Subject: Calvert Cliffs Nuclear Power Plant
Units Nos. 1 & 2, Dockets Nos. 50-317 & 50-318
Follow Up Actions Resulting from TMI-2 Incident

DRAWING CHANGE NOTICE

JOB NO.	DRAWING NO.	REV. NO.
11865	6750 IE-79 SH. 27B	X
DCN NUMBER		DATE
IE-79-2006		10-12-79
PROJECT APPROVAL		
<i>JMS</i>

JOB NO. 11865	DRAWING NO. 6750 M-633-2	REV NO. <div style="border: 1px solid black; width: 100%; height: 100%; text-align: center; line-height: 100%;">X</div>
DCN NUMBER M-633-2-2000	DATE 10-4-79	
PROJECT APPROVAL <i>JMS</i>

JOB NO. 11865	DRAWING NO. 6750 1E-79 SH. 27B	REV NO. <div style="border: 1px solid black; width: 20px; height: 20px; margin: 0 auto;"></div>
DCN NUMBER 1E-79-2006	DATE 10-12-79	
CONTINUATION SHEET		
PAGE 2 OF 4

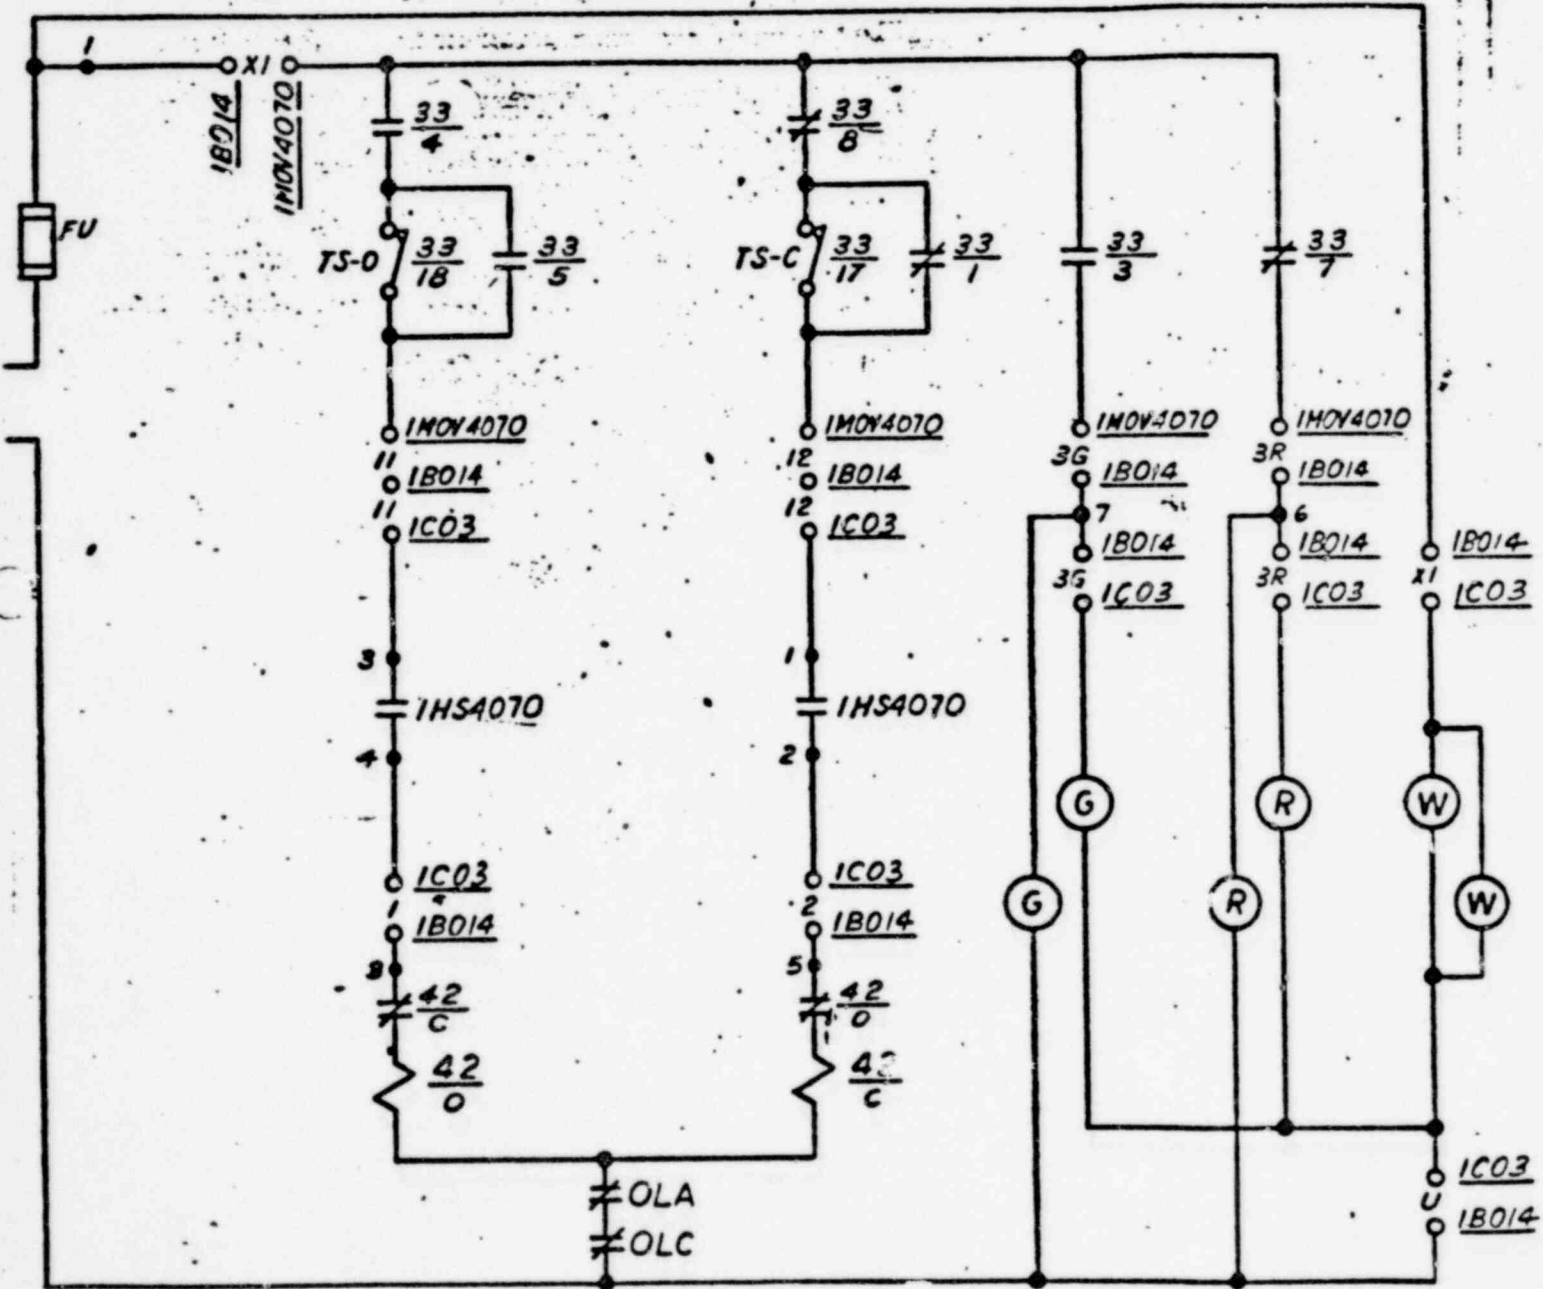
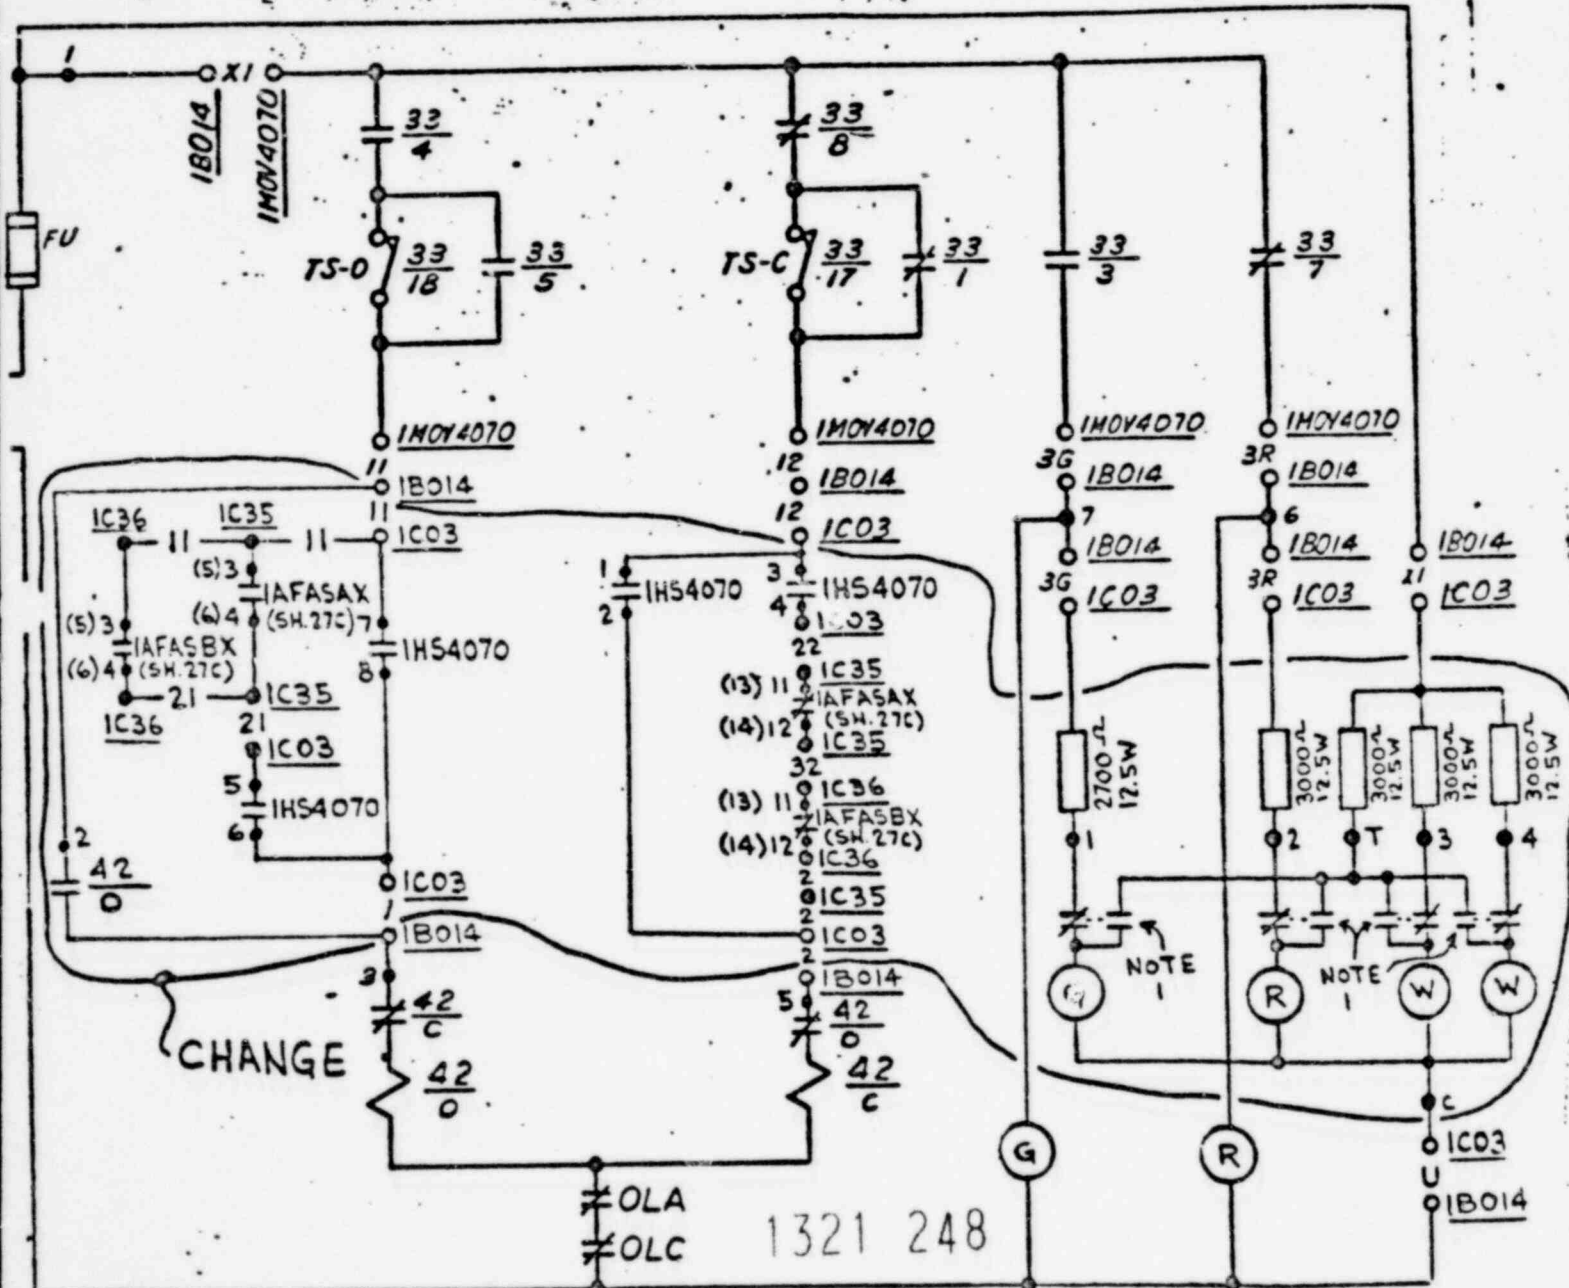
REASON FOR CHANGE: FCR 79-1035 UNIT NO 1

IHS4070 USED AT IC03
HONEYWELL TYPE CHC 910AEA011
MAINTAINED CONTACTS

IHS4070 & IHS4071 USED AT IC03

- NOTES:
1. PUSHING IN ON LIGHT CHANGES CONTACT STATE
 2. TERMINAL NOS IN () PERTAIN TO SCH. IBO414

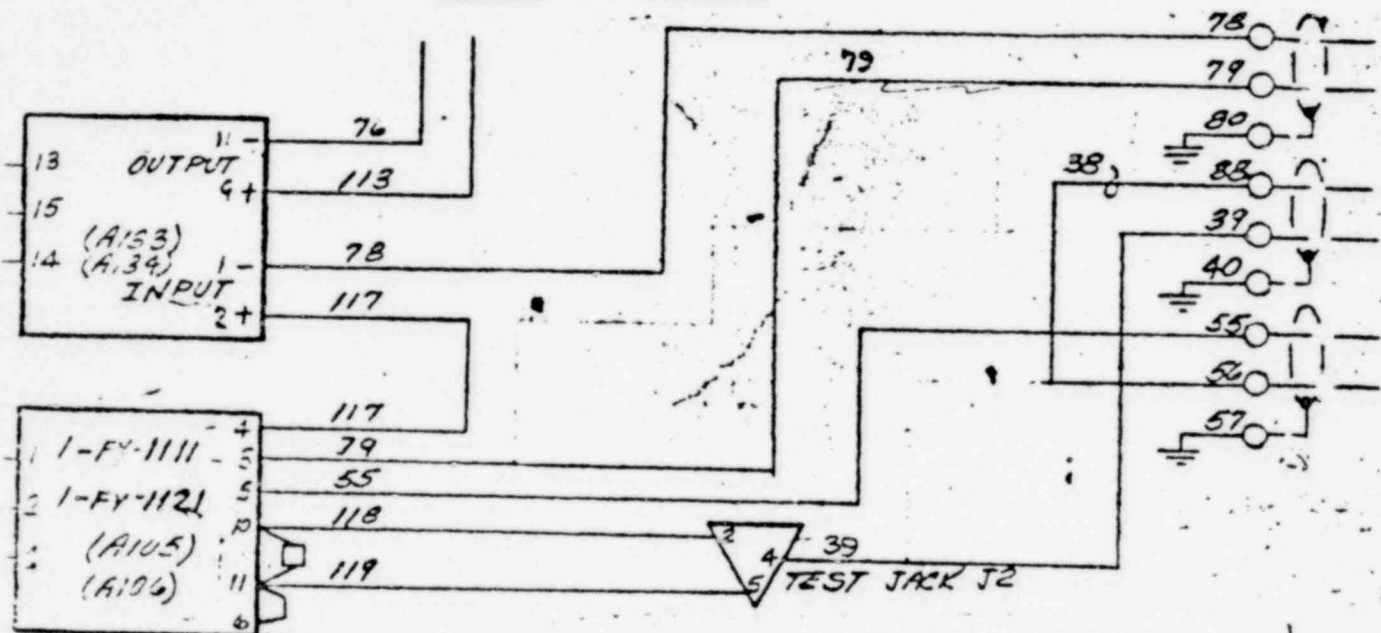
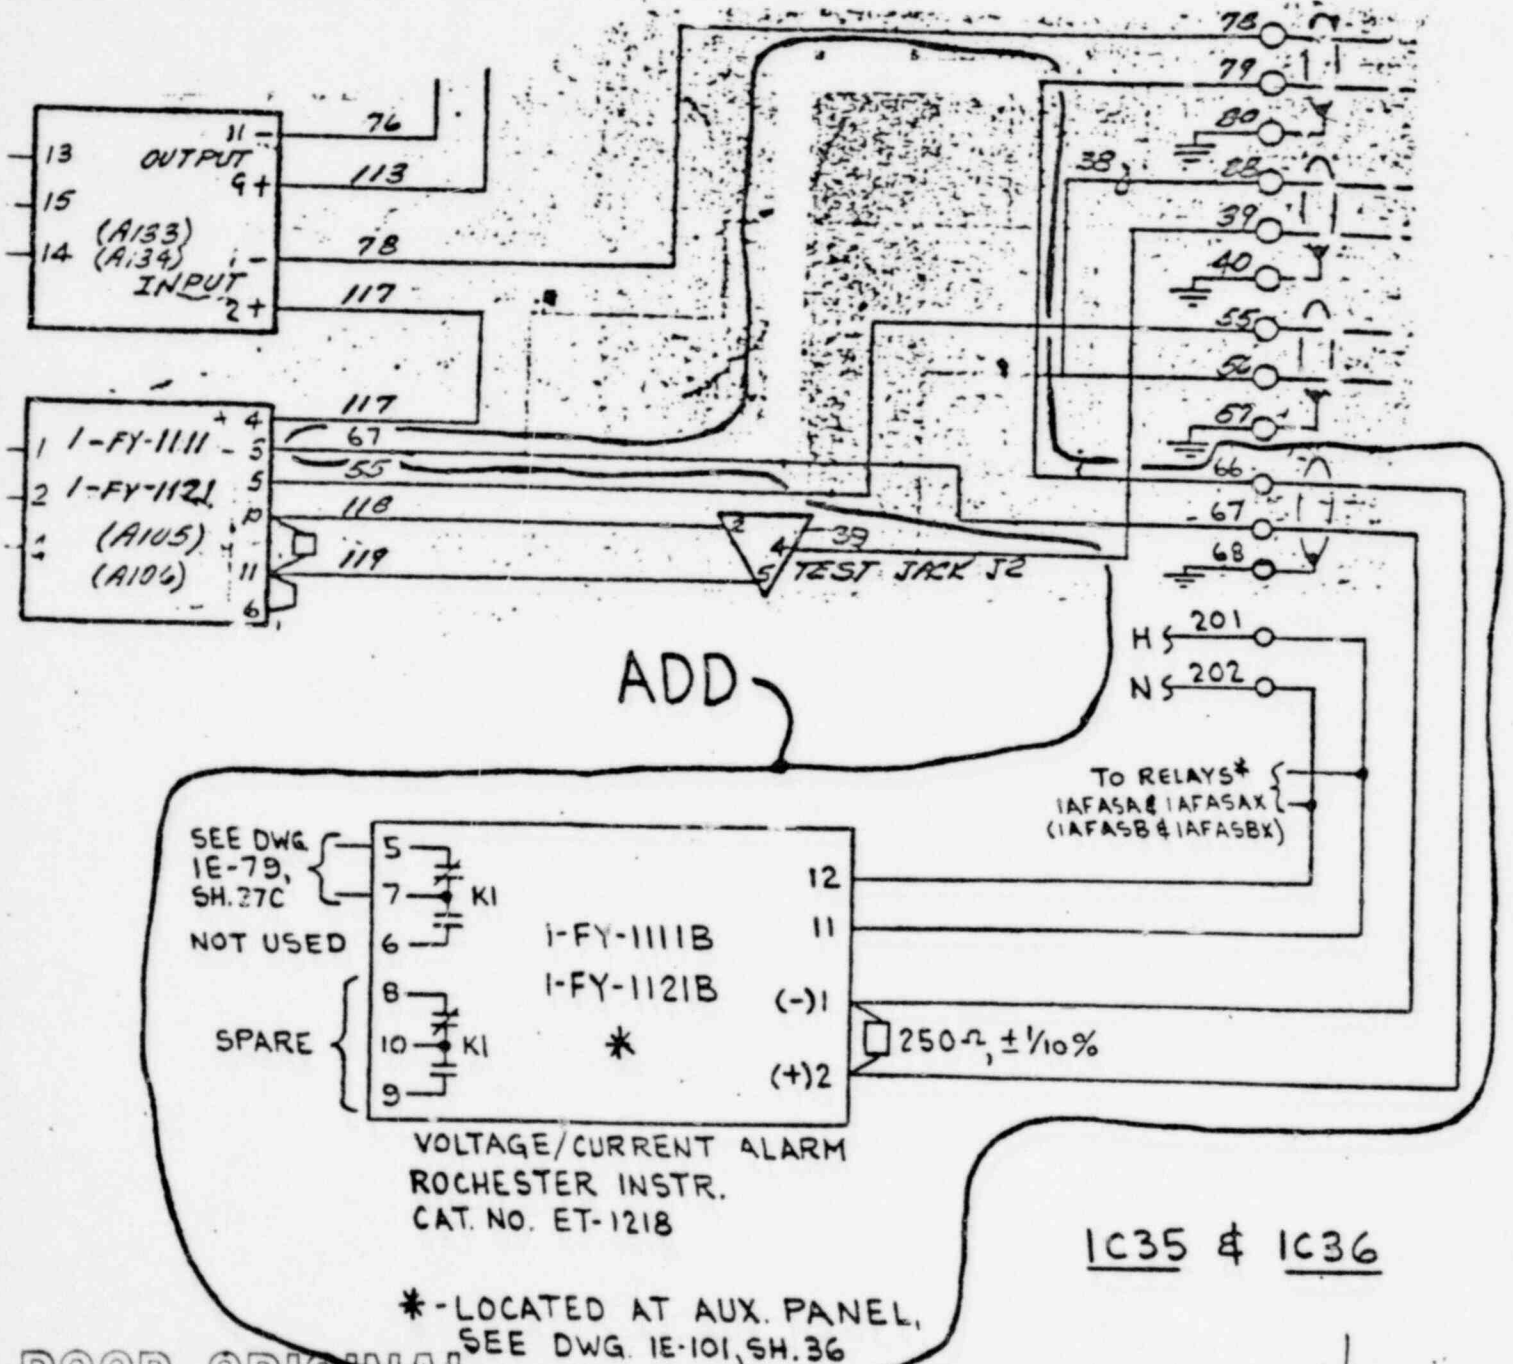
REASON FOR CHANGE: FCR 79-1035 UNIT NO. 1
(REF MFR# WD56E2456) ✓

* - LOCATED AT AUX. PANEL,
SEE DWG. IE-101, SH. 36
